# MEMORANDUM

Re: Modifications to Design Review approval at approximately 534 East 2100 South  
Izzy South: Design Review - PLNPCM2020-00222

**PROPERTY ADDRESS:** 534 East 2100 South  
**PARCEL ID:** 16-19-227-005-0000  
**MASTER PLAN:** Sugar House (inside); Central Community (adjacent)  
**ZONING DISTRICT:** CB (Community Business District)

NORTH ELEVATION | 2100 SOUTH

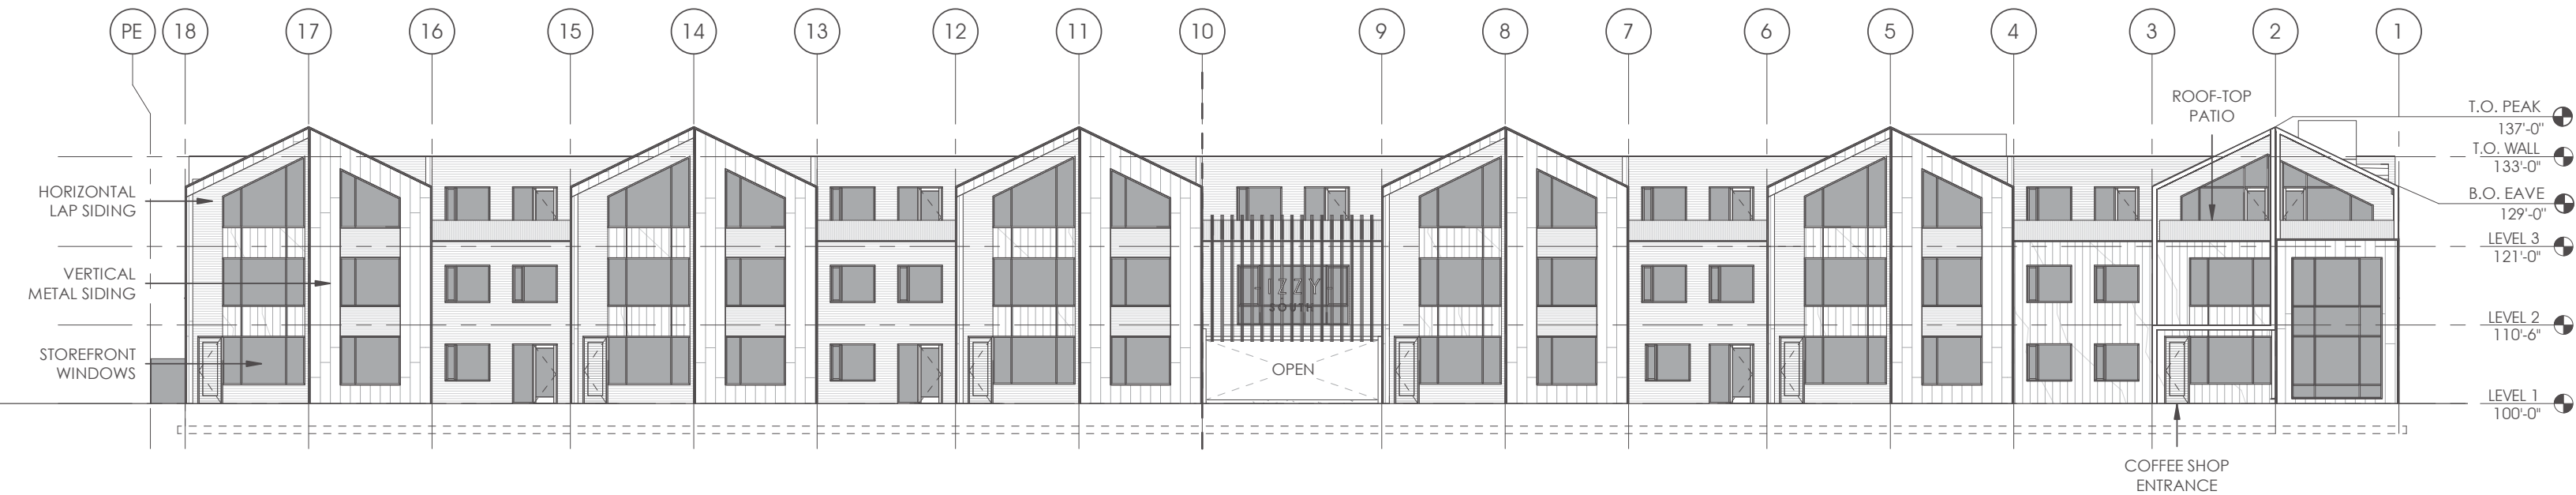
The applicant seeks to swap some wood siding for EIFS on the third story of the north façade (street facing) and swap wood siding for metal panel on portions of the projecting bays on the north façade. Additionally, they seek to swap wood lap siding for EIFS on the first and third stories on the south façade. The proposed modifications to the approved design are found in the drawings located in Attachment B and are outlined in their submitted narrative found in Attachment A. Specifically, the following design changes have been proposed by the applicant:

Proposed updates are shown as simple gray EIFS finish on upper terraces on both the front and back of the building, along with some minor modifications to the metal panel vs. lap siding locations.

EAST ELEVATION | UINTA GOLF

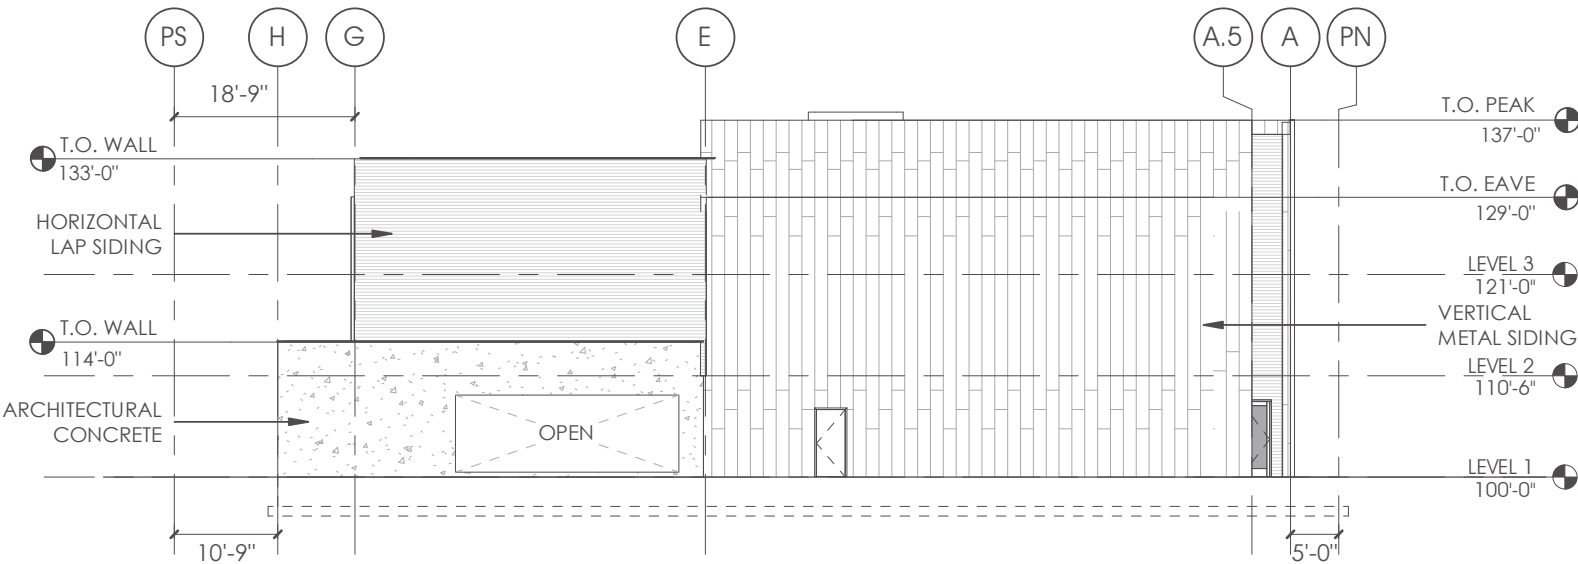
Project palate will be clean, contemporary, and simple: primarily architectural cast concrete around the parking garage, with a mix of vertical metal panel and horizontal lap siding

This building elevation is 6'-0" from the adjacent Uinta Golf building, and will be a wall with no openings. Uinta Golf is approximately 25'-0" tall and will cover a majority of this elevation.

## WEST ELEVATION | RESIDENCE & GAS STATION

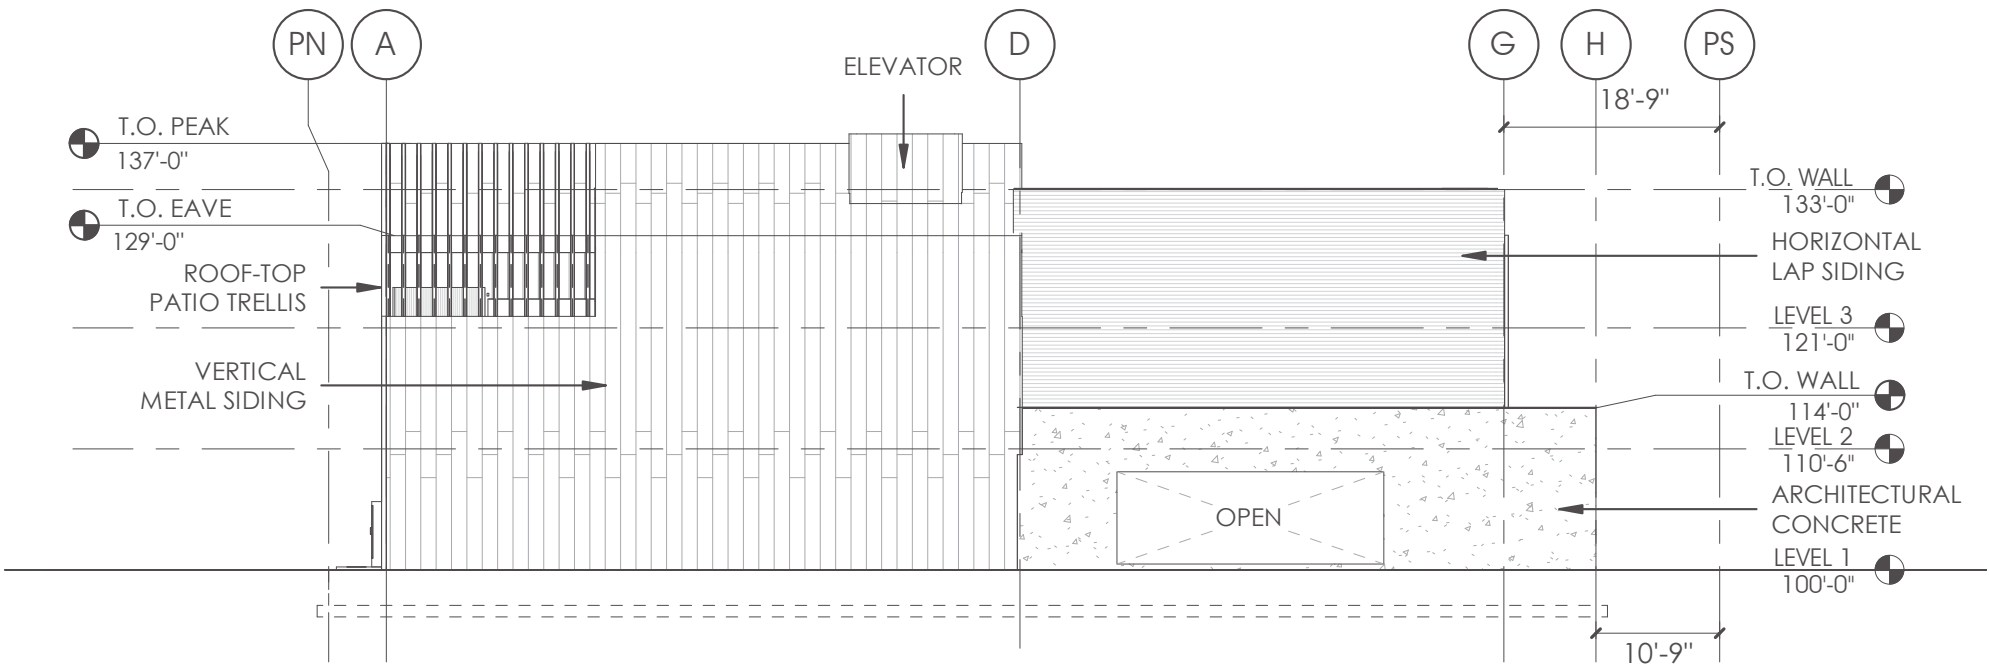
This building elevation is 0'-0" from the adjacent property line, and will be a wall with no openings. Additional detailing of the coffee shop trellis will soften this elevation, along with minor steps between building material elements
